STAFF REPORT

Subject: Appeal of Condition of Approval for Reconstruction and Expansion of an Existing Pier, 1590 North Lake Tahoe Blvd., Placer County, California, Assessors' Parcel Number (APN) 094-160-008, TRPA File Number ERSP2020-2095; Appeal No. ADMIN2022-0014

Requested Action:
To consider and act upon an appeal filed by Robert Adelman of Special Condition 3.B.6 to Permit No. ERSP2020-2095. Attachment A. The permit allowed Mr. Adelman to remove an existing nonconforming pier and reconstruct a new, conforming, expanded pier. Special Condition 3.B.6 requires Mr. Adelman to remove all of the old existing pier lakeward of highwater (6229.1'). Mr. Adelman asks the Governing Bard to remove the special condition because he desires to keep a portion of the old pier deck and a nonconforming sun deck bump out in addition obtaining the new expanded pier.

Re: Statement of Appeal - Appeal File Number ADMIN2022-0014; TRPA Project File Number ERSP2020-2095

SHEET L1.0

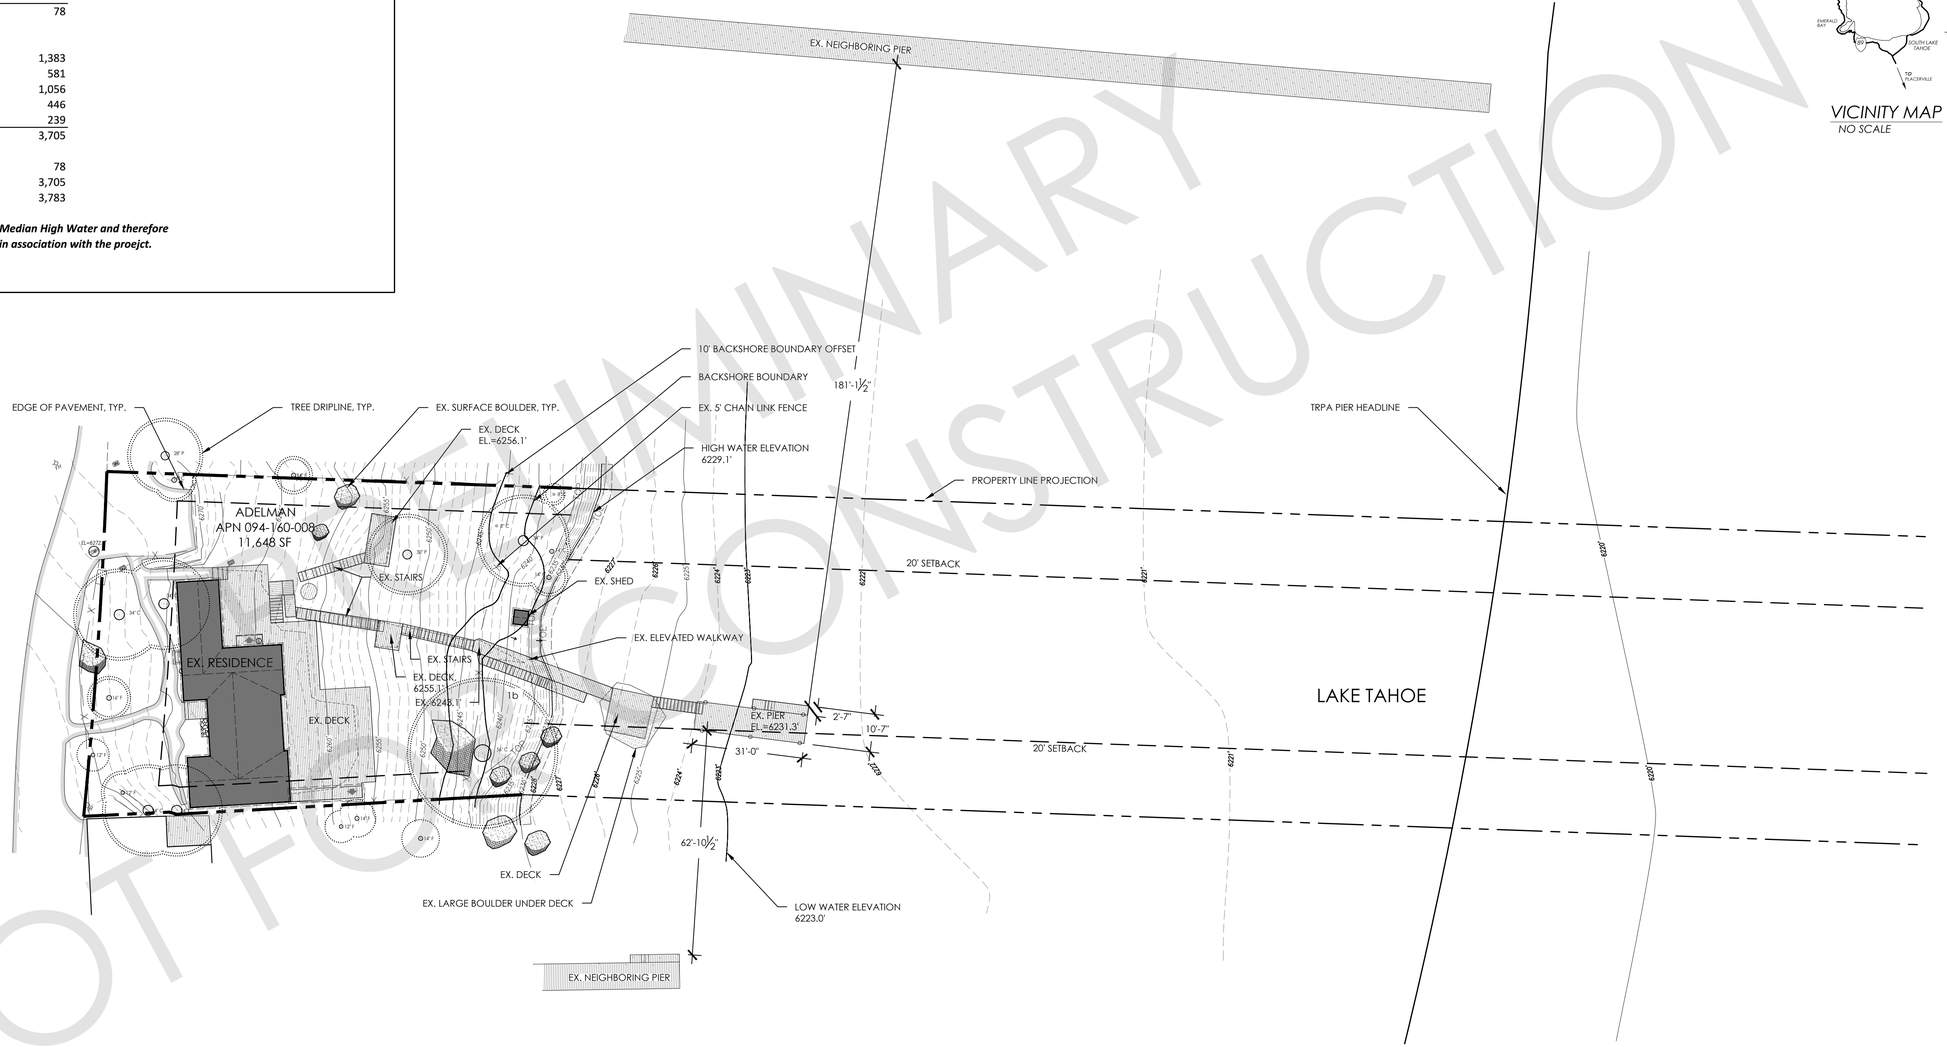
8. Revise the coverage table on Sheet L1.0 to reflect the proposed changes associated with the necessary change in pier access. Include a breakdown between the removed coverage in Class 1c and Class 1b as well as the relocated coverage in Class 1c and Class 1b. Identify the amount of restoration credits that will be required for the additional coverage in Class 1b.

SHEET L2.0

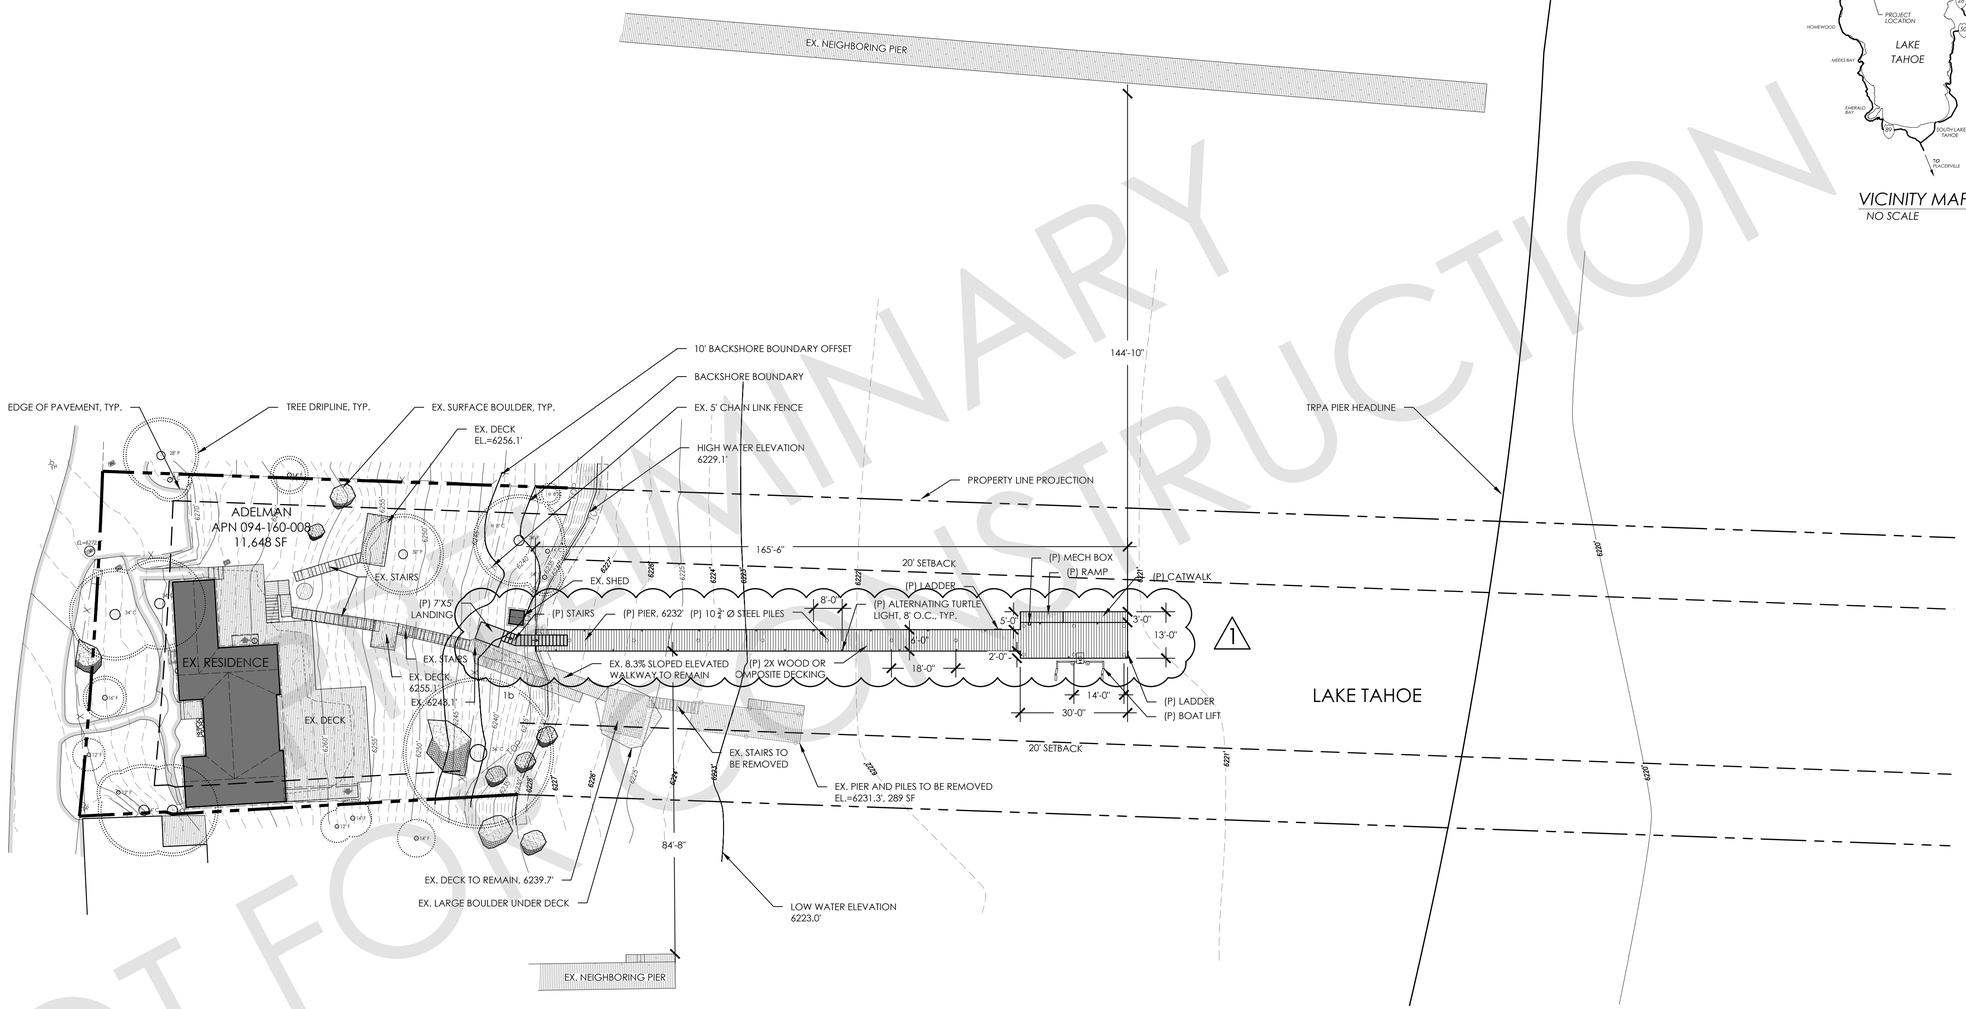
1. On Sheet L2.0 note which mooring buoy will be converted, identified by the mooring number and the corresponding tag number.

2. On Sheet L2.0 delineate the location of the turbidity curtain and include allowance for barge access.

3. On Sheet L2.0 add a note stating "There will be no staging activity on the shoreline, and all access associated with pier demolition and construction activities shall occur from the lake by barge; and delivery, removal, and staging of all construction equipment and materials shall occur on the barge."

4. On Sheet L2.0 add a note stating no containers of fuel, paint, or other hazardous materials may be stored on the pier or shoreline.

5. On Sheet L2.0 include a plan notation that indicates pile driving operations and other piling installation methods (i.e. pinning, etc.) shall require the installation of caissons for turbidity control **upon the discretion of the TRPA inspector upon a pre-grade inspection**. A floating fine mesh fabric screen or other material approved by TRPA shall be installed underneath the pier decking to capture any fallen materials during pier demolition and reconstruction. The floating screen and caissons may be removed upon project completion and after a satisfactory inspection by TRPA to ensure that all suspended materials have settled.

6. On Sheet L2.0 identify that the existing pier structure will be removed. All existing structure lakeward of the High Water Line of 6,229.1 shall be removed as a result of this project.

SHEET L2.1

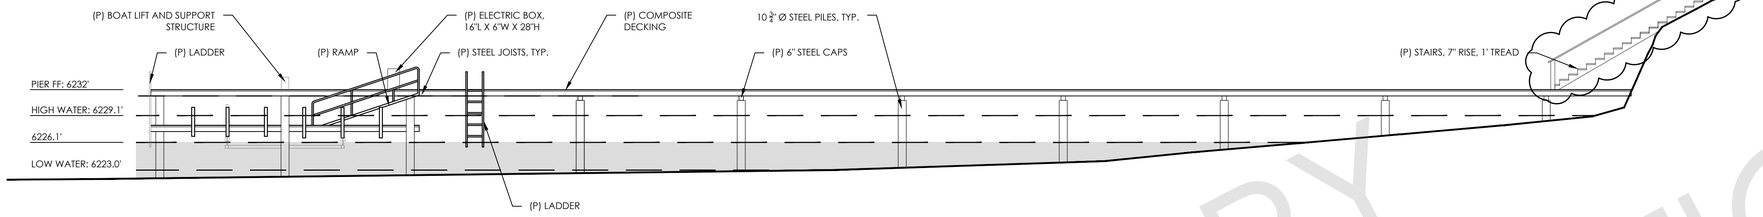
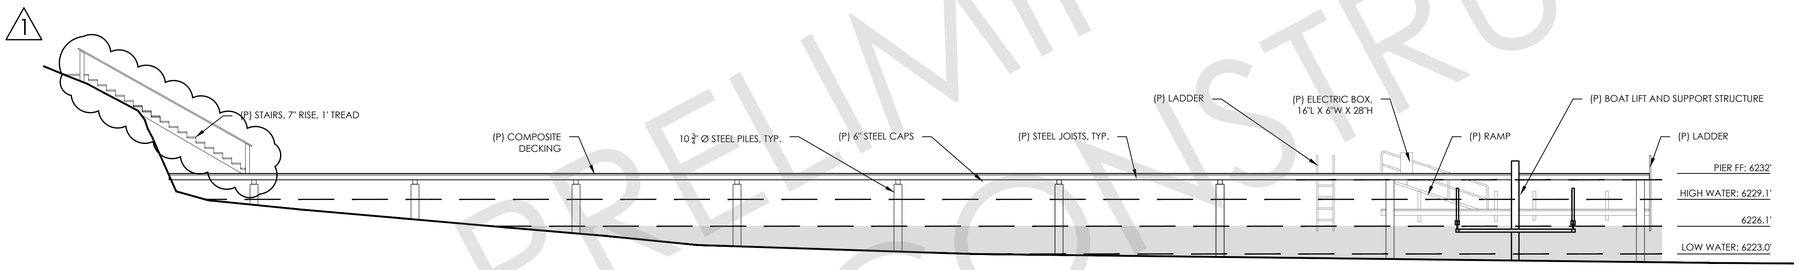
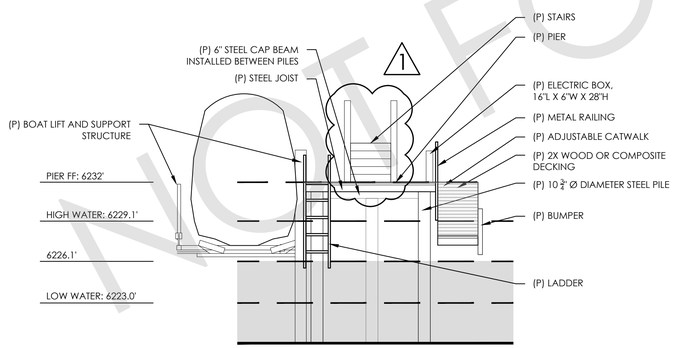
D. Sheet L2.1 shall include the following language:

The project area complies with Level 5 Scenic Review, Option 2 – Visual Magnitude System (Subsection 66.3.3.E.2 of the TRPA Code of Ordinances). The existing structures at the property result in a composite contrast rating score of 27, with an allowable visible area of 1,565 square feet. The total existing visible area is 1,093.7 square feet, leaving 471.3 square feet of remaining allowable visible area. The additional visible mass associated with the pier will be mitigated through a reduction of the visible mass associated with the property of 439 square feet (219.5 s.f. additional visible mass x 2.0). The remaining allowable visible mass associated with the property will be 32.3 square feet (471.3 s.f. – 439 s.f. = 32.3 s.f.).
